Village of Cottage Grove

## PLAN COMMISSION

Tuesday, September 15, 2020

**RE:** **Glen Grove Apartments – General Development Plan**

| MARK              | DATE                      | DESCRIPTION |
|-------------------|---------------------------|-------------|
| SHEET TITLE:      | EROSION CONTROL PLAN      |             |

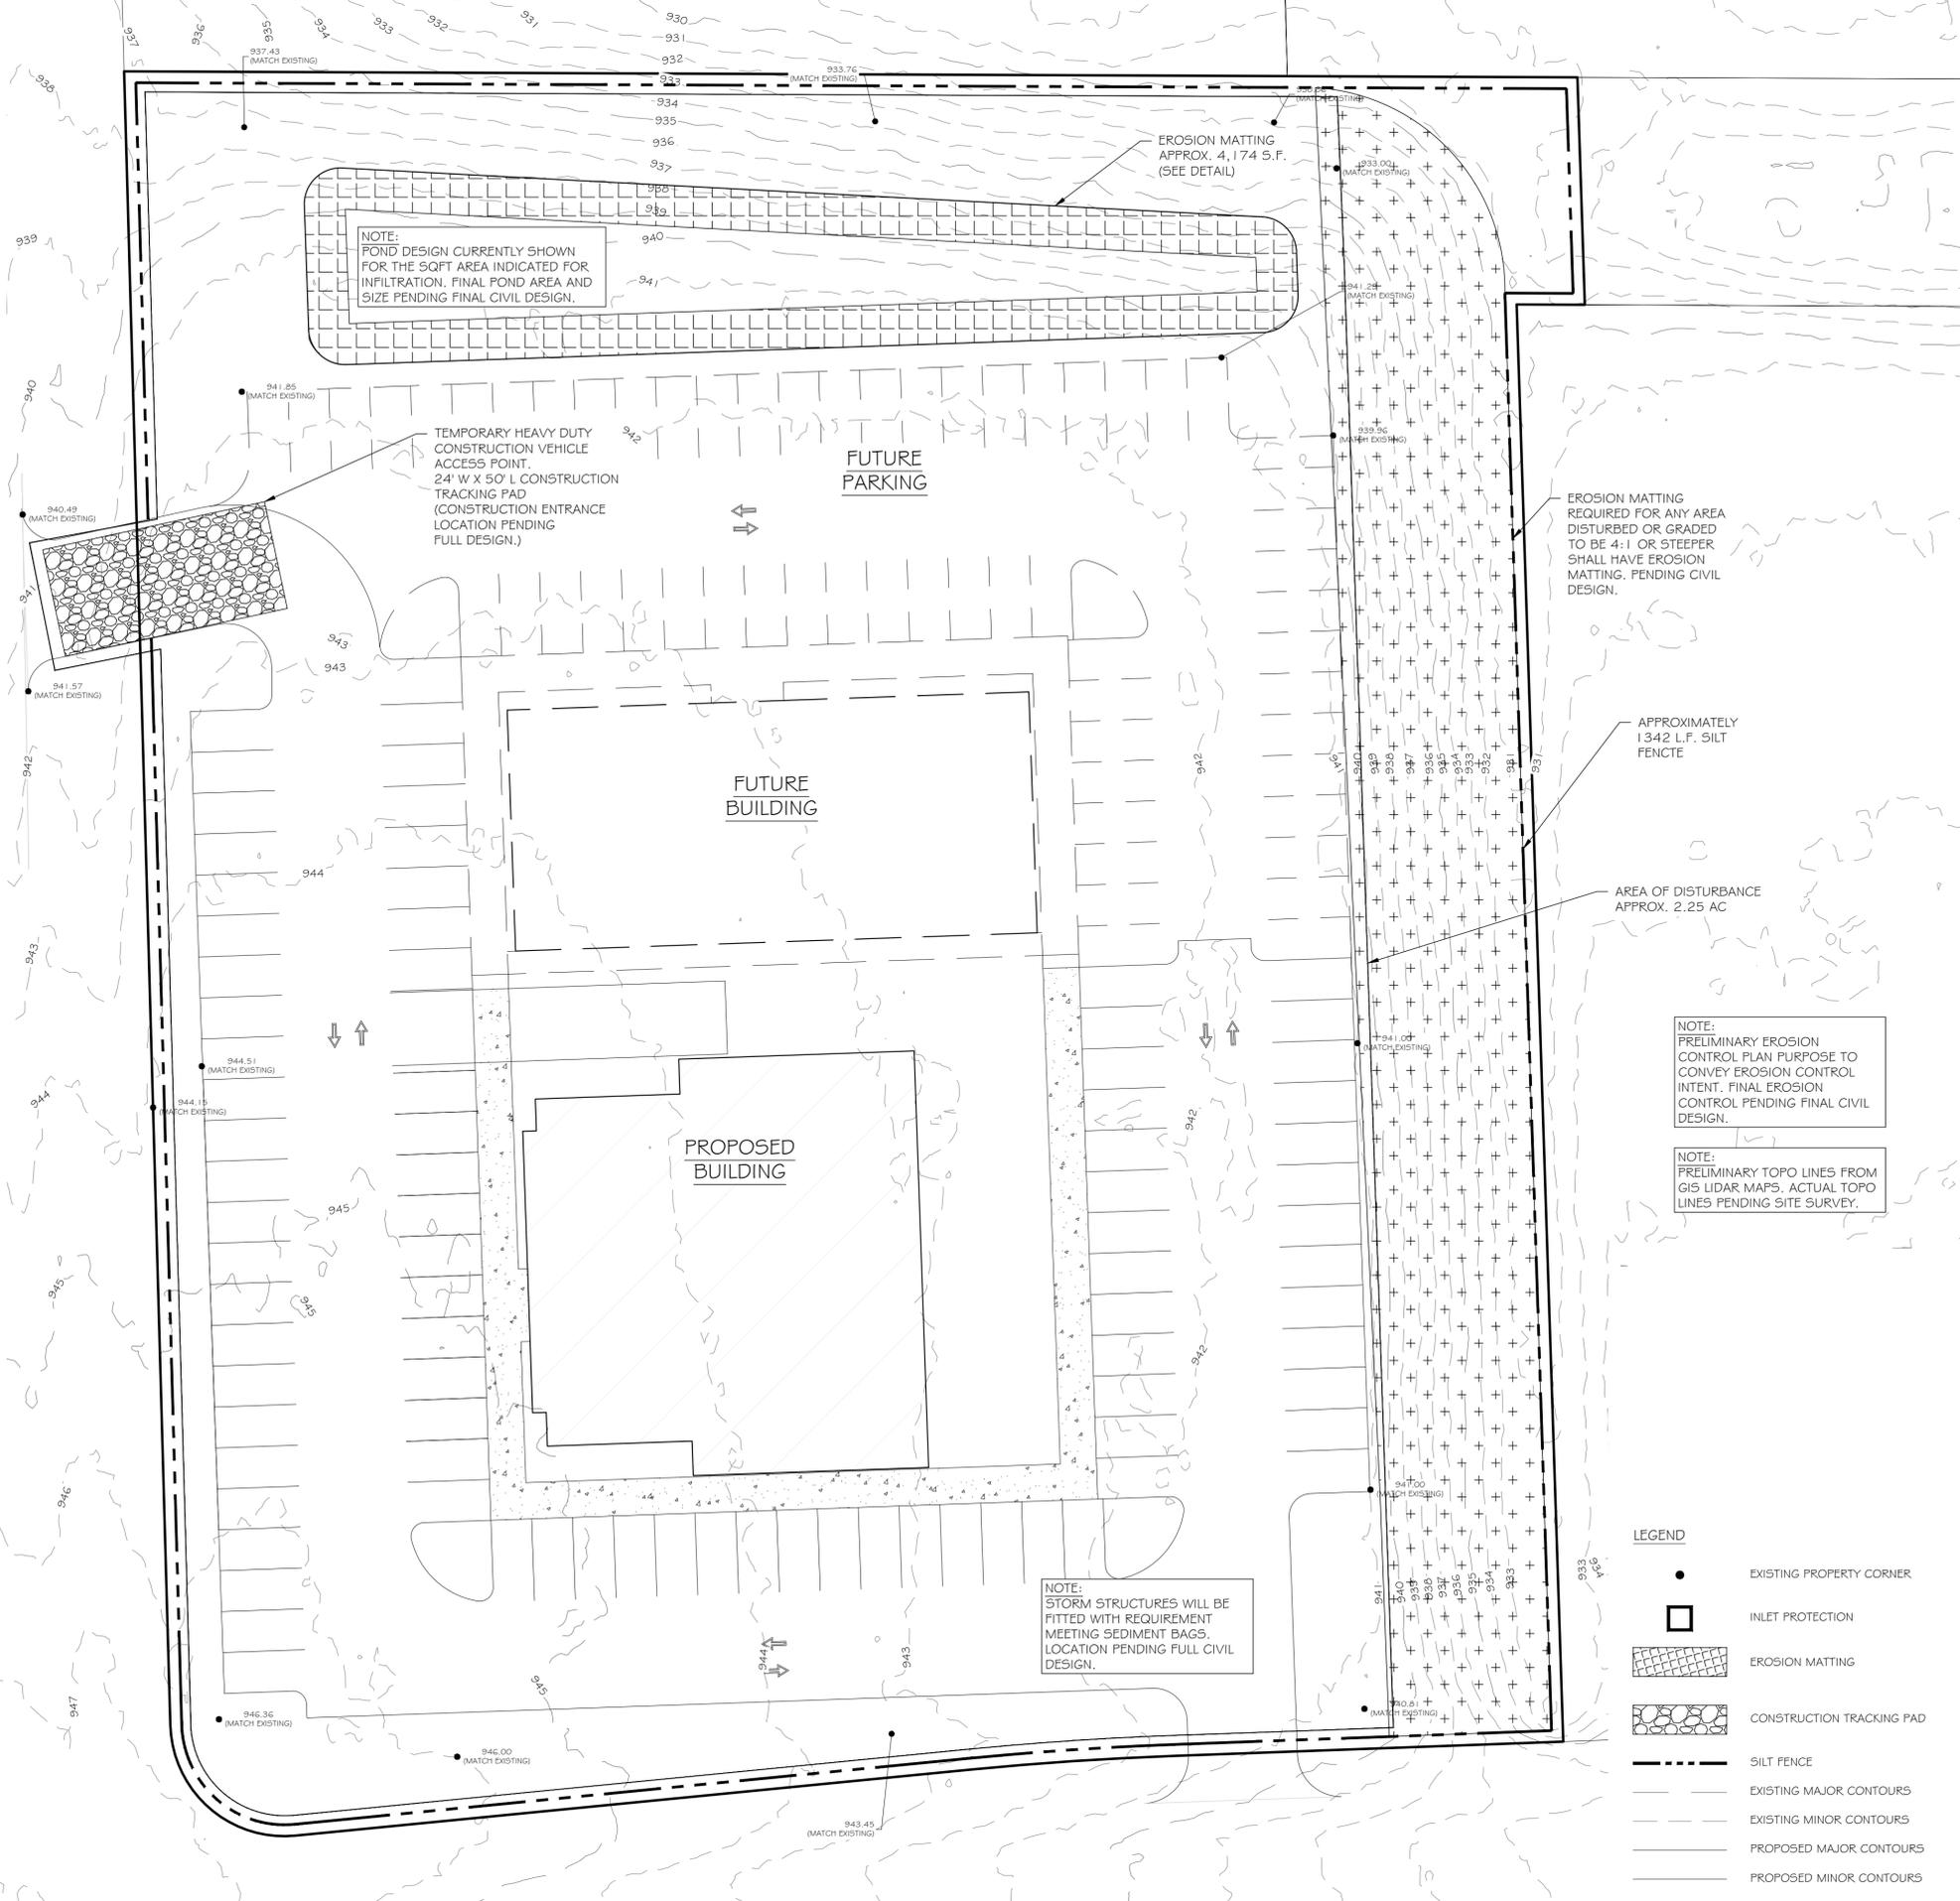
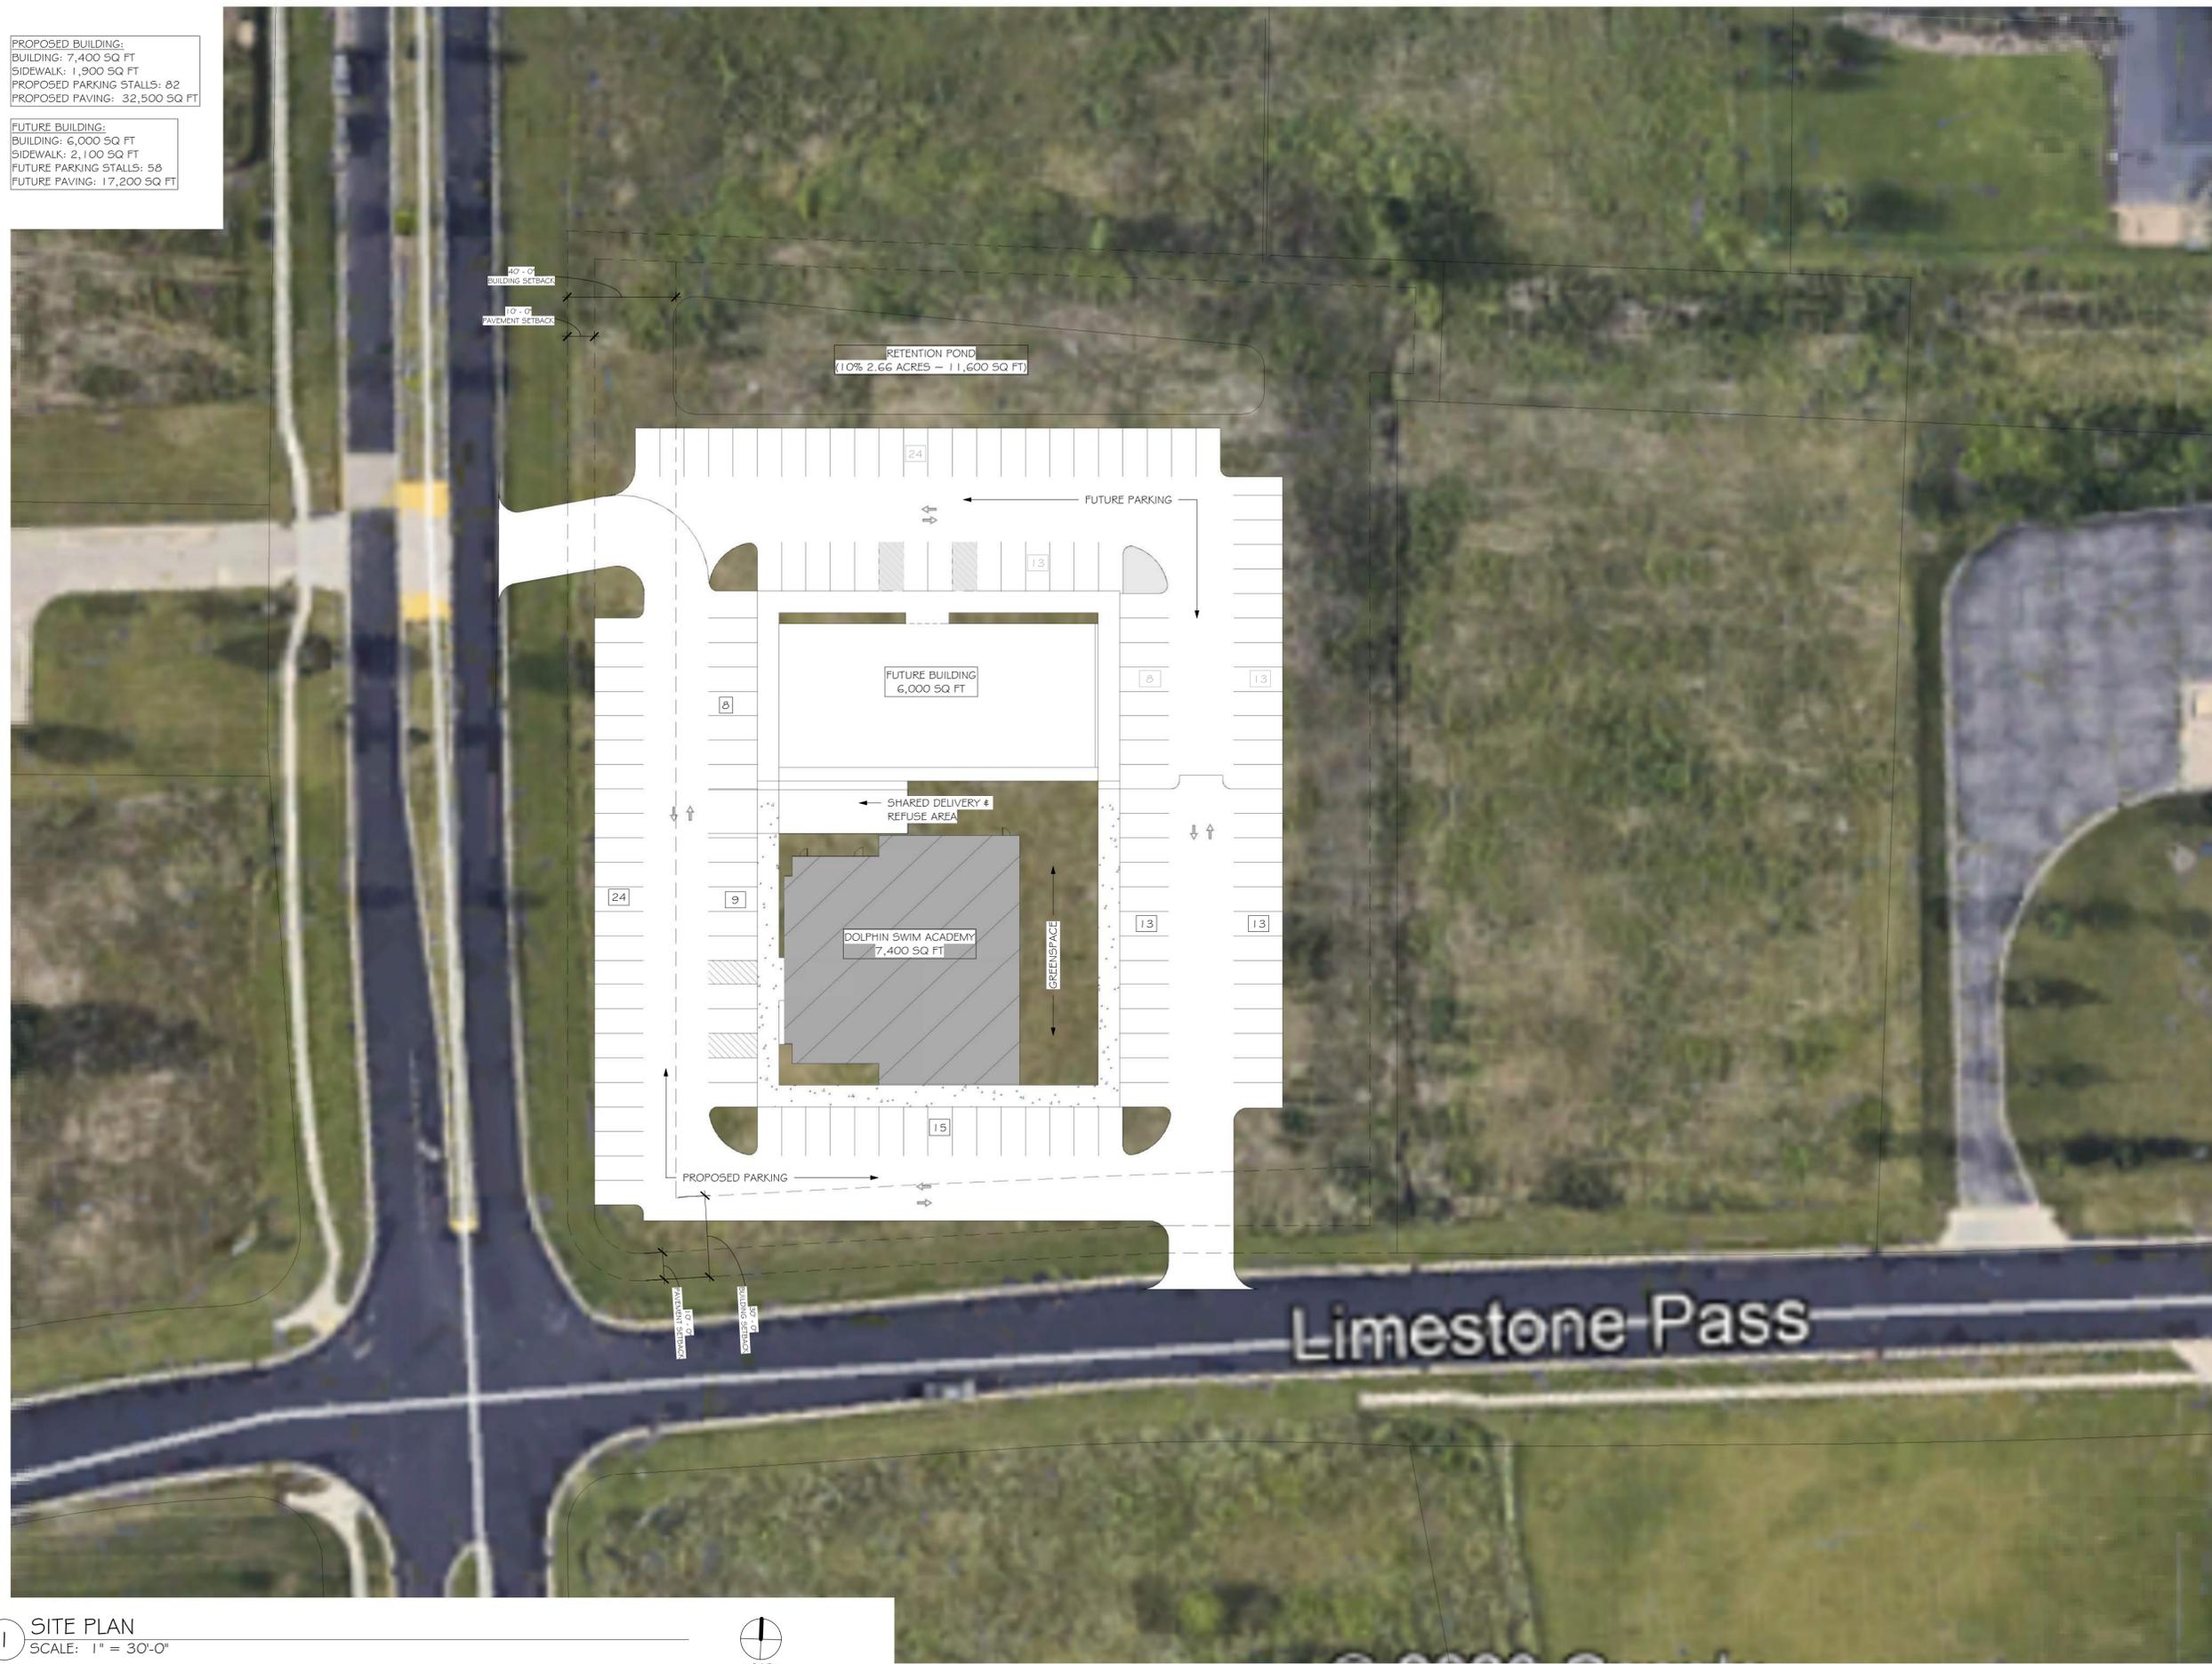
1. A detailed construction plan will be required for review.
2. Parking areas should have curb and gutter around the perimeter per Section 325-75 F.(2) of the Village code. Parking stalls shall meet the Village standards.
3. A lighting plan will be required.
4. Consider breaking up long parking runs with 20 or more stalls with landscape islands. Landscaping to meet Village code.
5. ADA stalls and pathways shall be noted on the final plans.
6. Sidewalk should be installed on the west side of the property along with a planned crossing of Limestone Pass to the south for a continued sidewalk on the easterly side of Landmark Drive. Sidewalk on the entire south frontage is not included within properties further to the east of this development.

7. Utility plans and sizes will need to be included.

1. MSA is currently working on evaluating the soils based on soil borings on the site and plan to initiate a correspondence with the WDNR to determine if infiltration is exempt on the site or to what rate would have to be provided for the site based on the soil conditions. The final stormwater design will reflect the DNR response.
2. The Developer will have to provide a rain garden equal to 10% of the roof area per the Commerce Park covenants.
3. A Long Term Maintenance Agreement will be required for the site and approved by the Village prior to being recorded by the Developer.

SHEET TITLE  
**EXTERIOR ELEVATIONS & 3D VIEW**

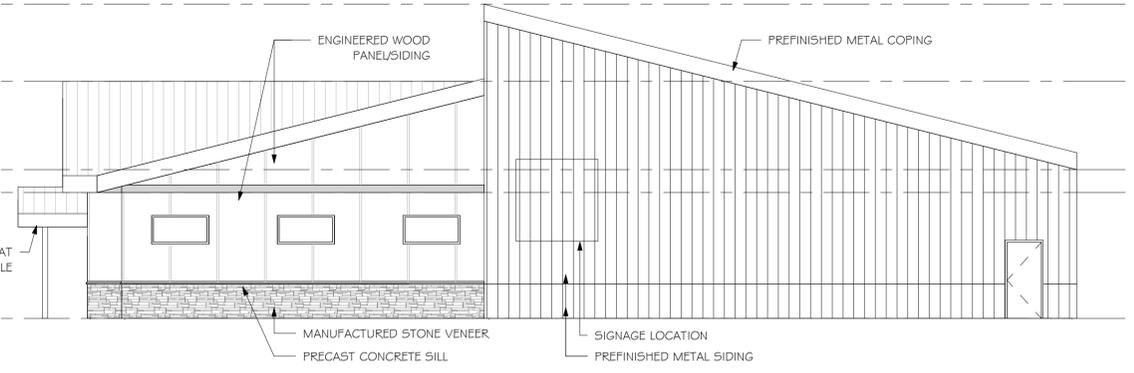
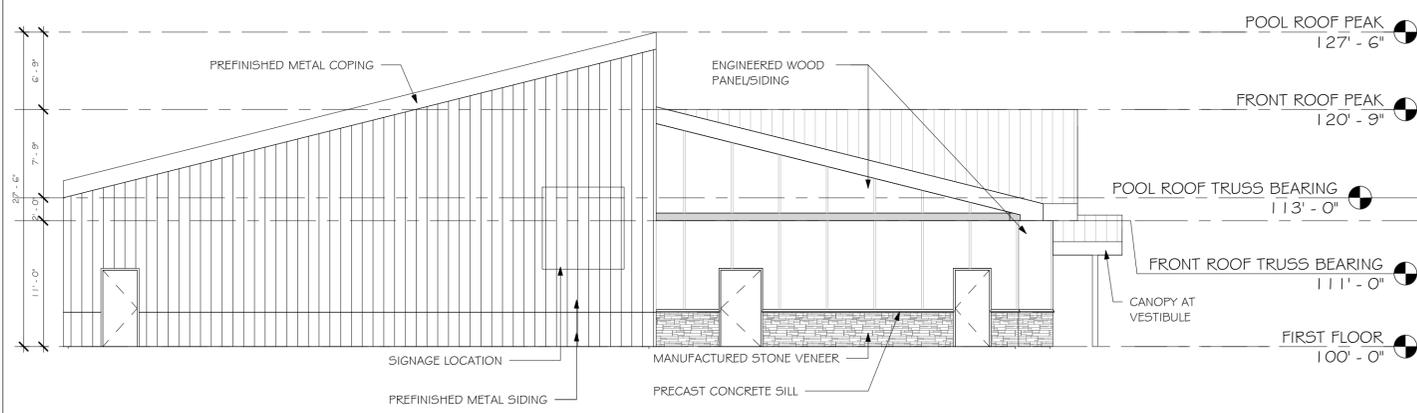
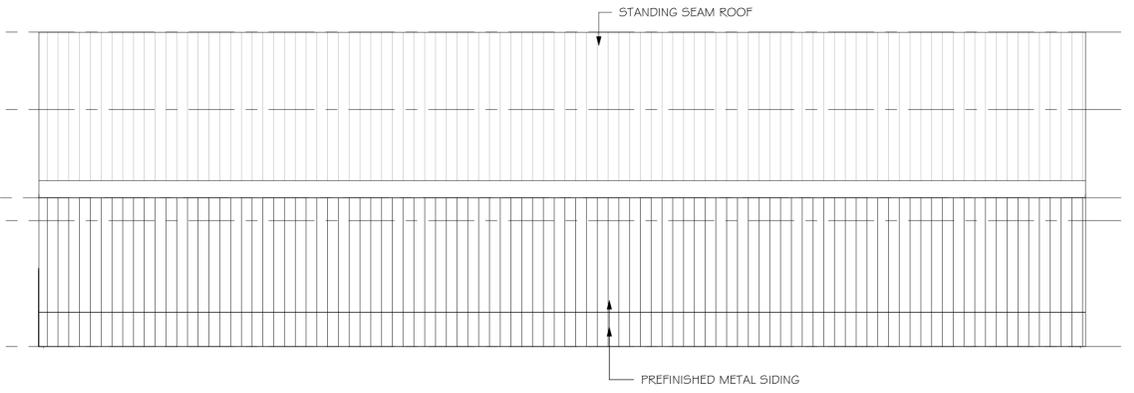
The Planned Office/Industrial chapter includes several design guidelines. The proposed project generally meets those guidelines. It should be noted that non-architectural materials such as metal siding with exposed fasteners should not be allowed in areas that are easily visible. It is not clear whether the metal panels on the proposed building facades have exposed fasteners.

Article IV(1)(C) provides building standards for the Planned Industrial portions of the park. Paragraph 1 states that “wood siding” is not allowed. The proposed building includes an engineered wood panel system on the front entry portion of the building. In the opinion of staff, these engineered wood panels are employed in a manner similar to an architectural metal panel as opposed to a residential style wood siding the covenants intend to prohibit and should be considered an acceptable material.

The covenants require screening of all exterior mechanical equipment. The applicant should verify locations of all equipment and provide details showing the method of providing adequate screening. This applies to both the architectural screening of rooftop equipment and using landscaping to screen ground mounted equipment.
